CALL NO. 300
CONTRACT ID NO. 141009
ADDENDUM # 2

Subject: Bell County, FD04 SPP 007 025E 000-001
Letting January 10, 2014

- (1) Revised - Notes - Pages 11-14 of 84
- (2) Deleted - Page 15
- (3) Revised - Notes - Pages 16-49 of 84

CUMBERLAND GAP TUNNEL - US25E
FD04 SPP 007 025E 000-001

**CUMBERLAND GAP TUNNEL
US 25 E NORTHBOUND
TYPICAL SECTION**

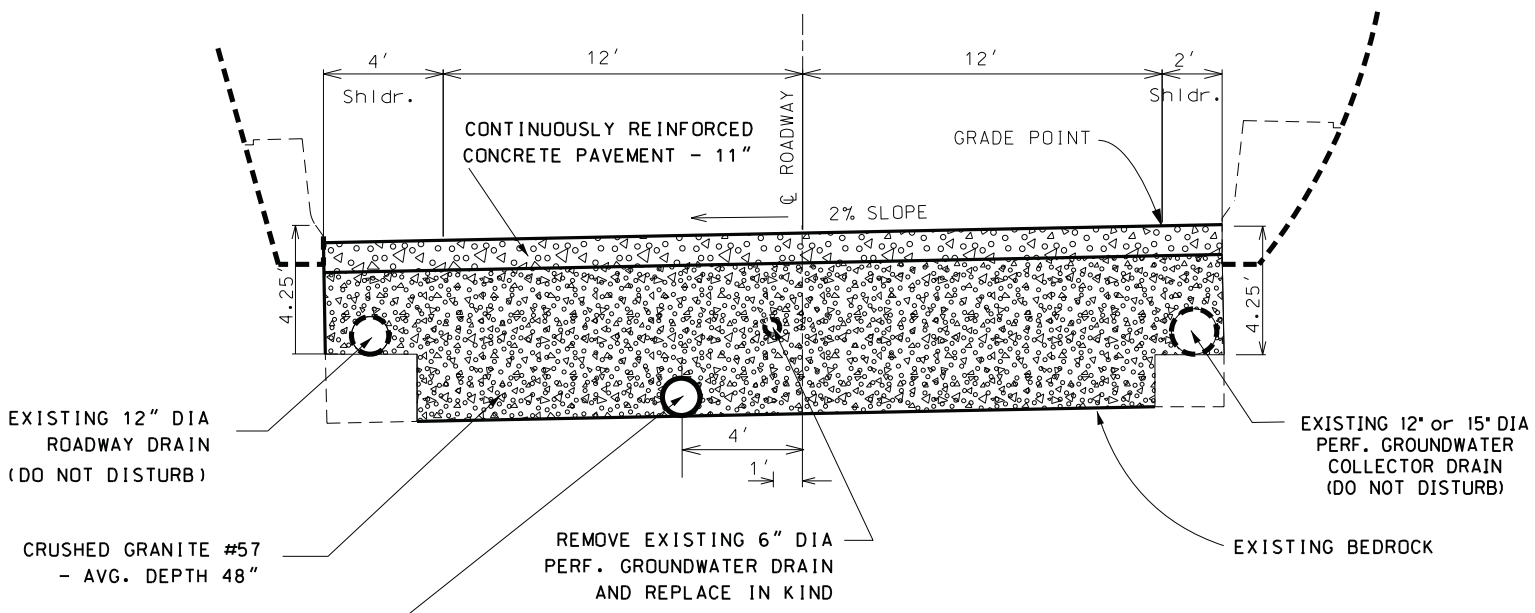
Note: Contractor is allowed to use a finer graded Granite material in the top 2 to 3 inches of the 48 inch depth Crushed Granite Granular sub grade. Granite Material used in the top 2 to 3 inches will conform in gradation to KDOT size No 78, 8's, or 9-M.

**CUMBERLAND GAP TUNNEL
US 25 E SOUTHBOUND
TYPICAL SECTION**

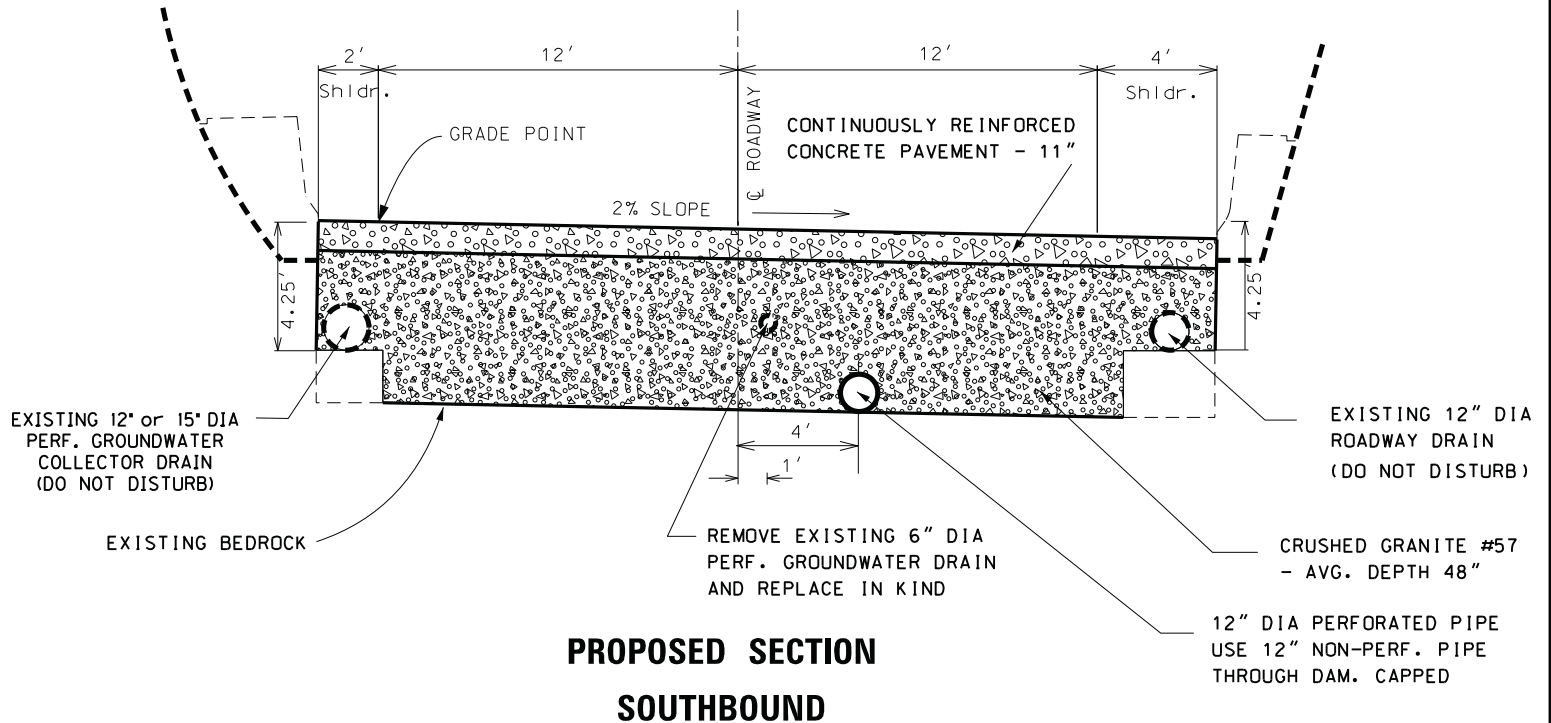
Note: Contractor is allowed to use a finer graded Granite material in the top 2 to 3 inches of the 48 inch depth Crushed Granite Granular sub grade. Granite Material used in the top 2 to 3 inches will conform in gradation to KDOT size No 78, 8's, or 9-M.
